### **ZONING BOARD OF APPEALS**

### INTER-DEPARTMENTAL REVIEW COMMITTEE REPORT

217 S. BREWSTER AVENUE

ZBA 21-01

Figure 1. North elevation showing proposed addition.

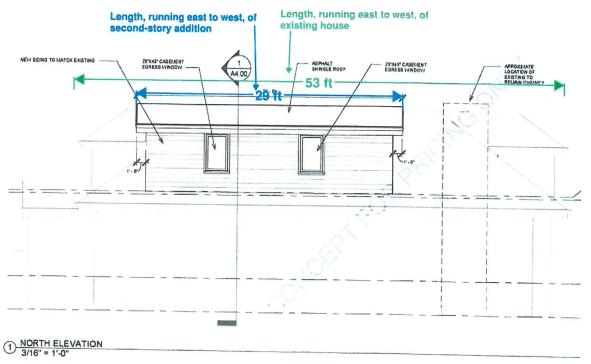
Staff does not believe that the proposed second-story addition will have a negative impact on adjacent properties. The height of the house with the proposed addition will be 20.6 feet (Village Code defines building height as the mean level between the eaves and the peak of the roof). Maximum building height in the R2 District is 30 feet. The peak of the roof of the house, which is currently 22.3 feet from grade, will not change with the proposed addition. Finally, staff notes that the addition when viewed from the adjacent property to the north is smaller in length than the existing house, minimizing the visual impact of the addition on the adjacent property. See Figure 1.

The petitioner proposes to build the addition over the footprint of the existing house. The addition will hold the side setback line of the existing house, and will be shorter in length than the first story of the residence. See Figure 1. The addition is not expected to impact light or air supply to adjacent property.
